RFB NO. 313086 - ADDENDUM NO. 6

### ARCTIC ANIMAL EXHIBIT AND CONCESSIONS

This Addendum is issued to modify, explain or clarify the original Request for Bid (RFB) and is hereby made a part of the RFB. Please attach this Addendum to the RFB. **Bidders must acknowledge all Addenda on the Bid Form.**

**CW1.1**  
COPYRIGHT 2013 WDM ARCHITECTS P.A.  
L:\313086\313086\_CW1.dwg 12/20/2013 11:32:58 PM 000001.DWG 11

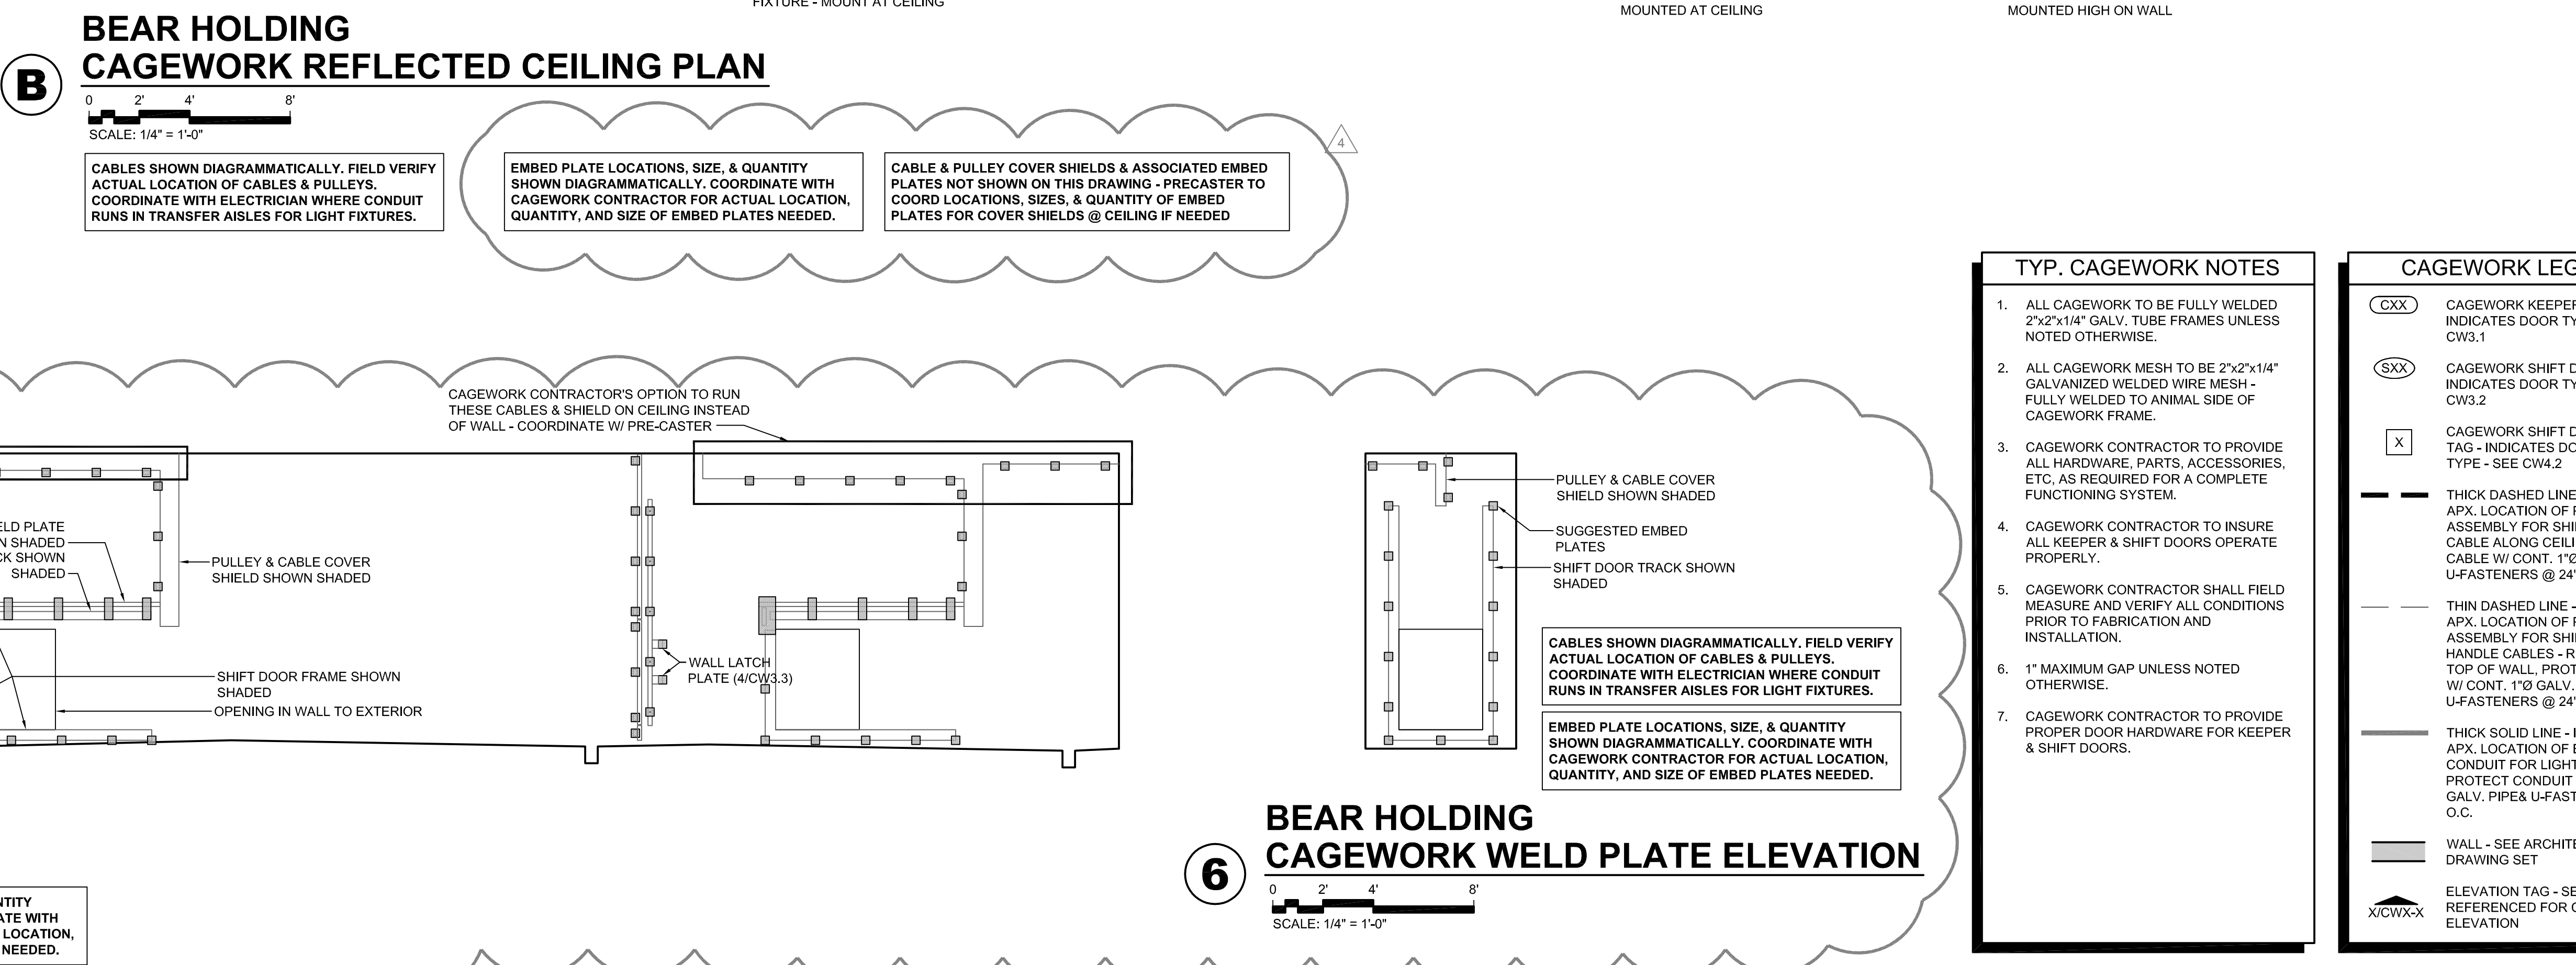
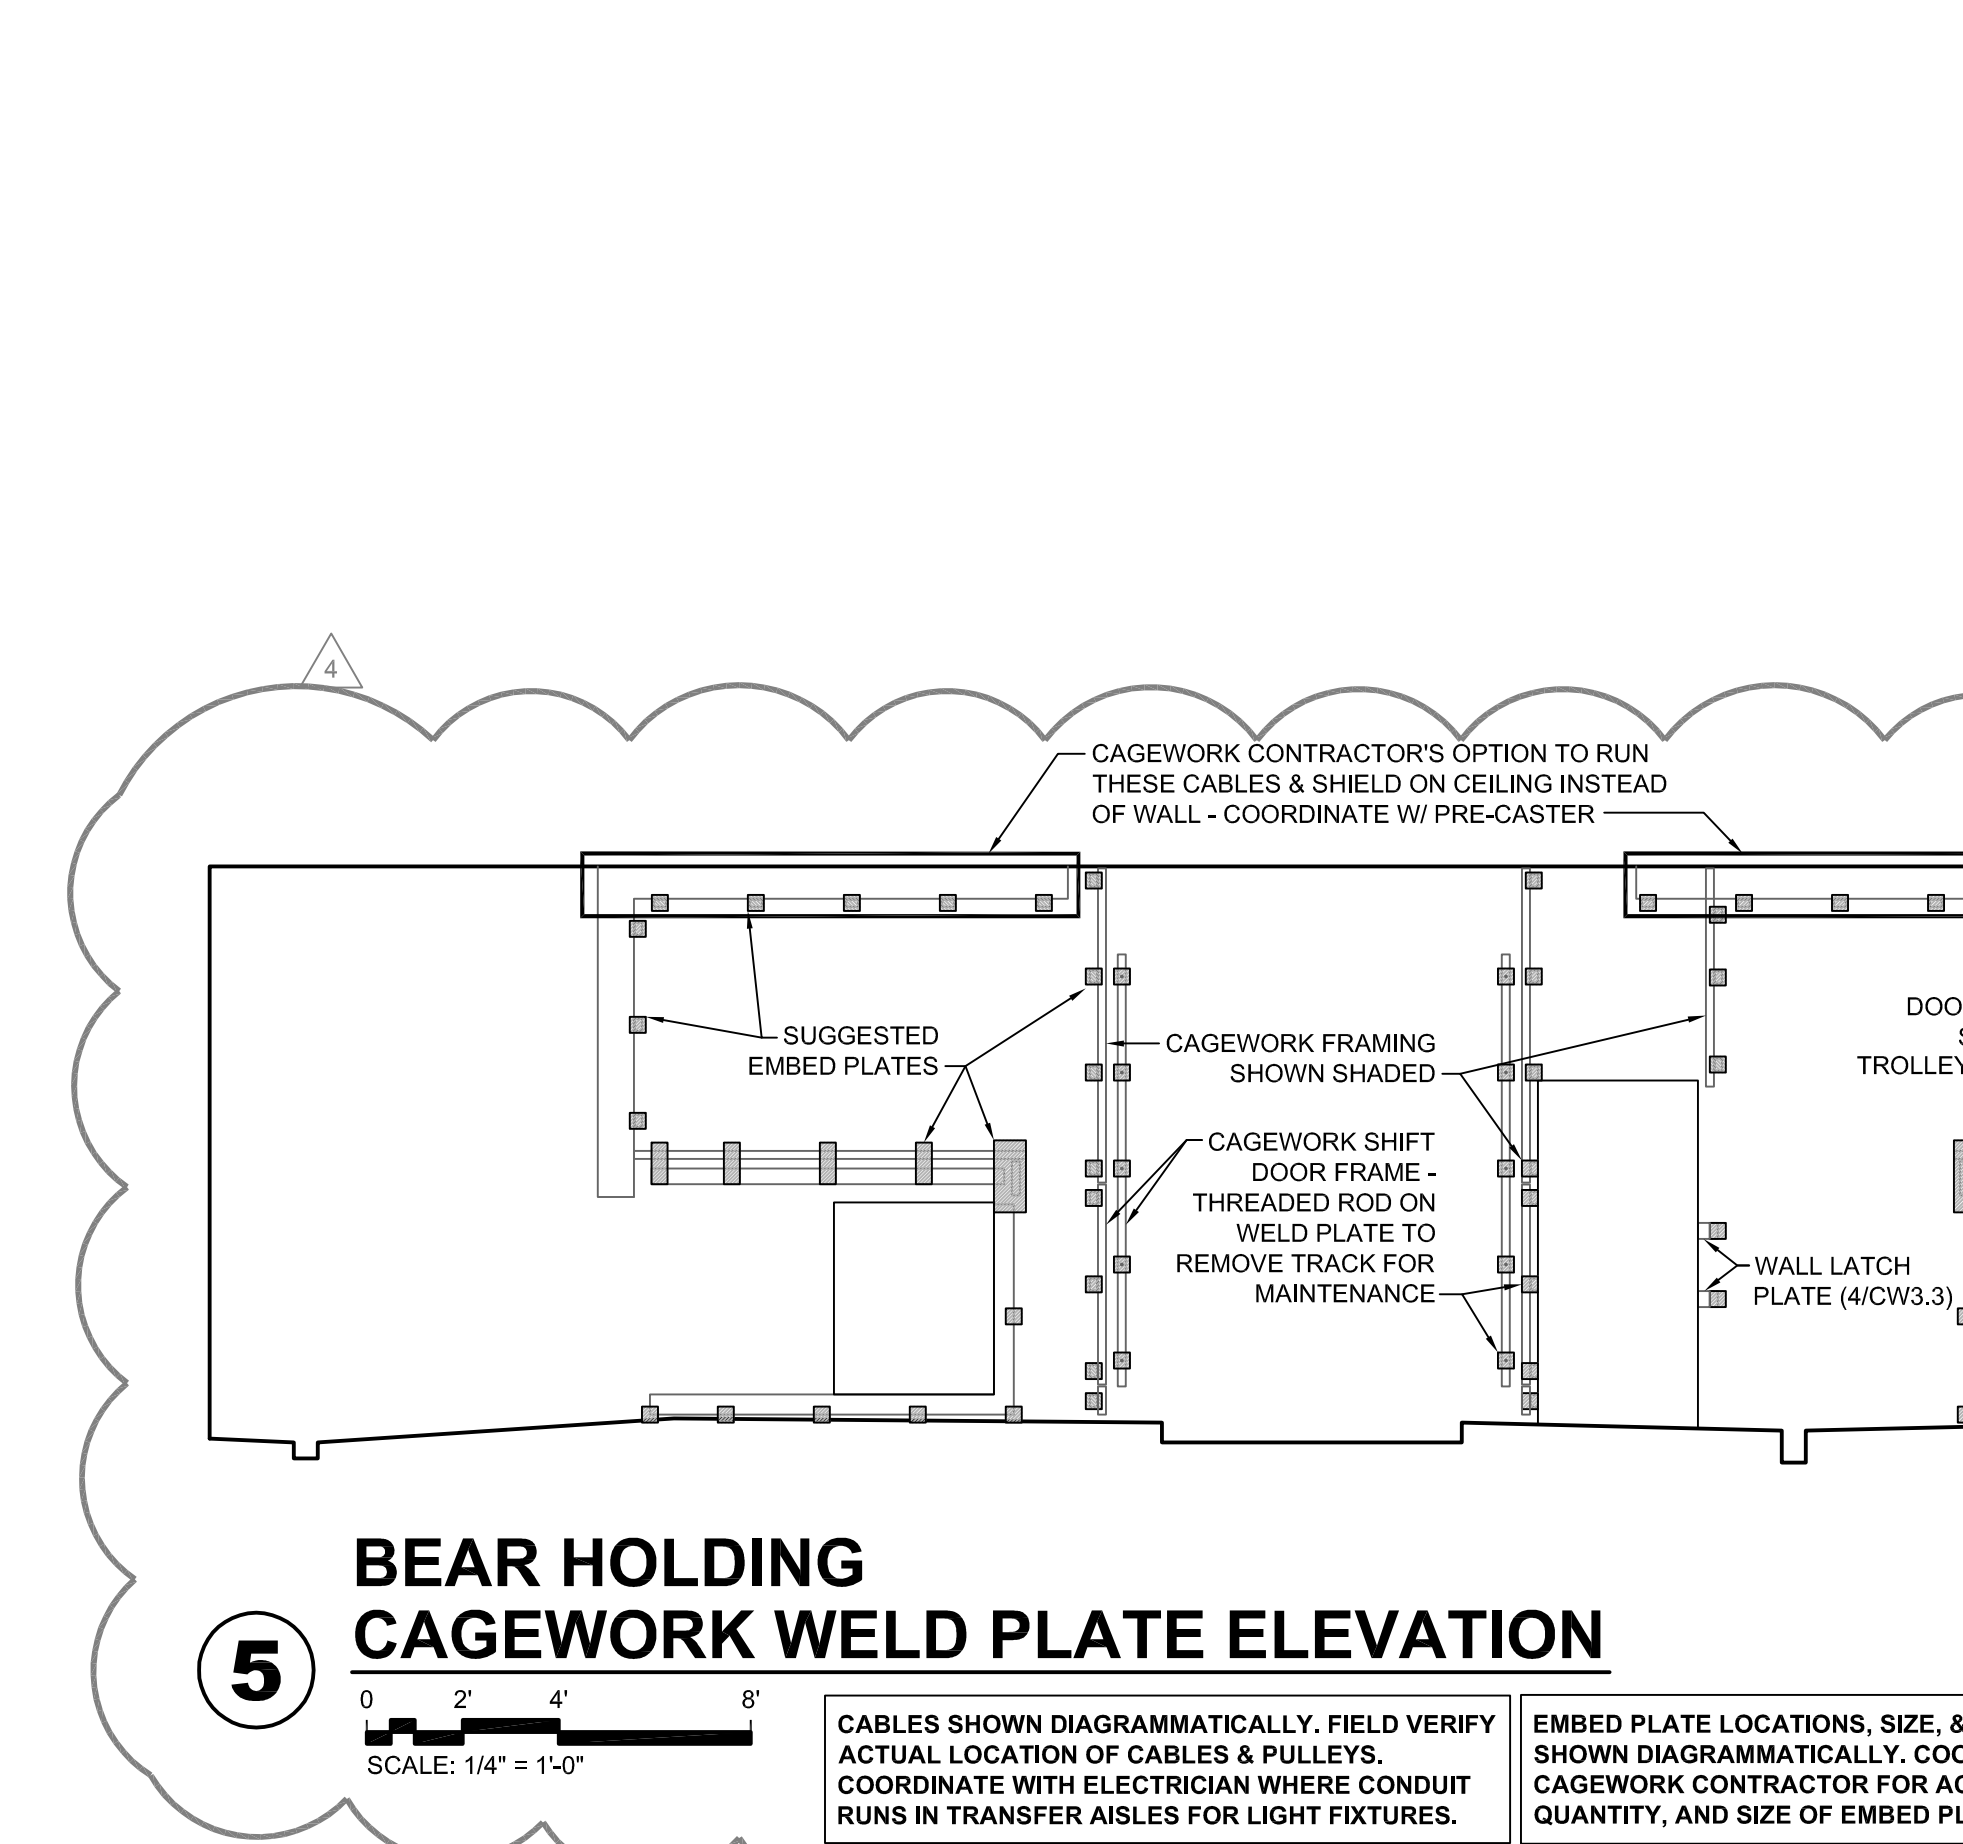
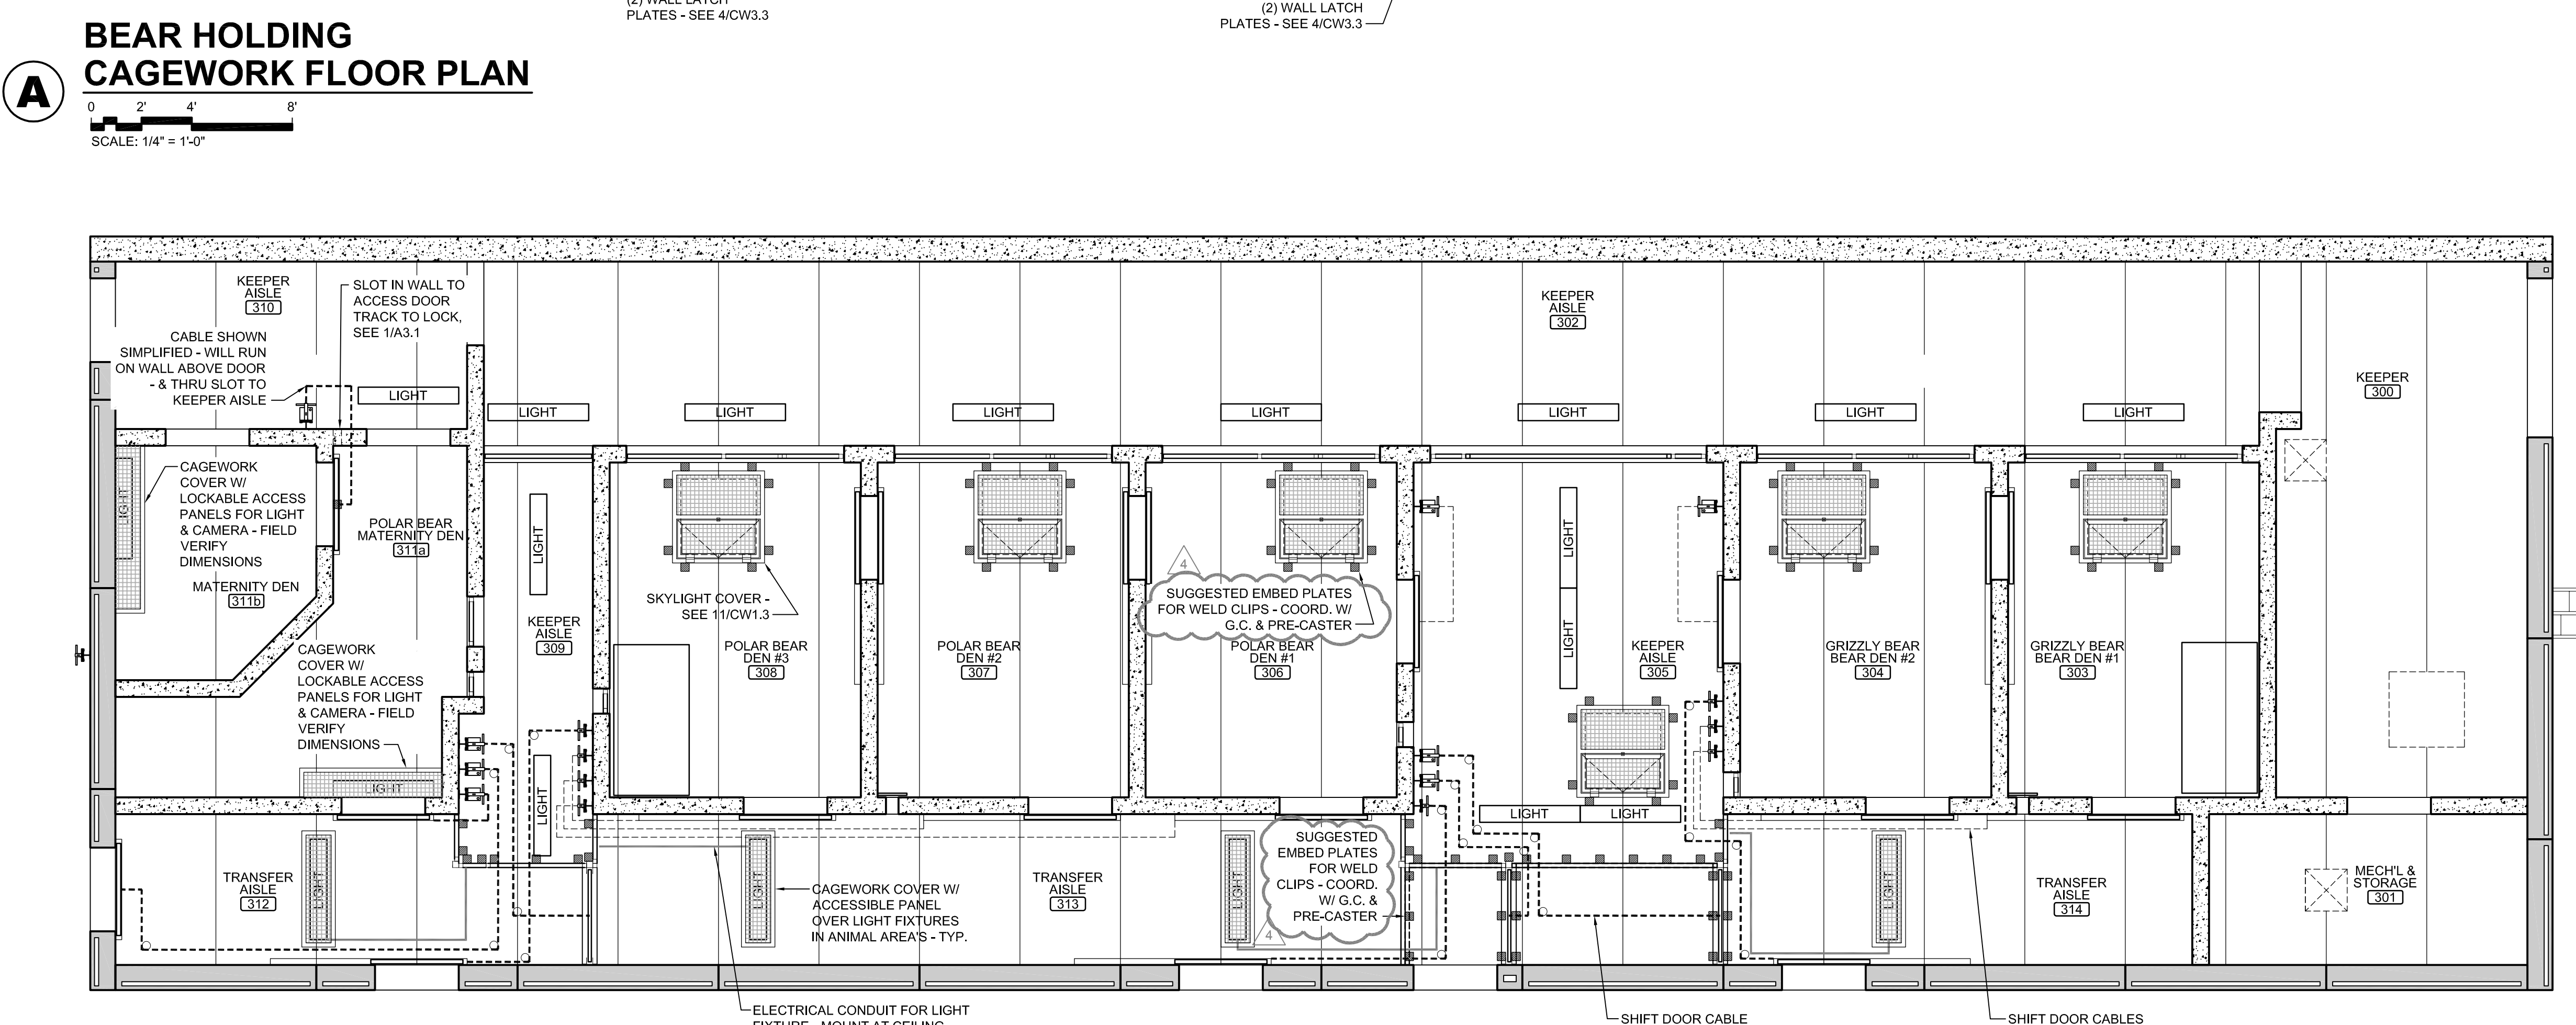
## **22. Sheet CW1.1**

- Revised sheet to show cagework weld plates in the RCP (B/CW1.1) as well as add two new elevations (5,6/CW1.1) indicating suggested approximate locations, size, & quantity of embed plates needed to fasten cagework & related items to precast ceilings & walls. Concrete precaster is to coordinate with cagework contractor for final locations, sizes, & quantity of embed plates. Note that all cable & pulley locations are shown diagrammatic, & final locations will be determined by cagework contractor and are to be coordinated with concrete precaster.
- See note on details 1-4/CW1.1 for pulleys that will be fastened to pre-cast concrete walls & ceilings. In addition, all steel plate pulley covers shields are to be ¼" galv. Steel instead of 1/8" galv. Steel plate.
- Polar Bear Transfer Crate equal to LGL #91190
- Replace existing sheet CW1.1 with new sheet CW1.1 included in this addendum.
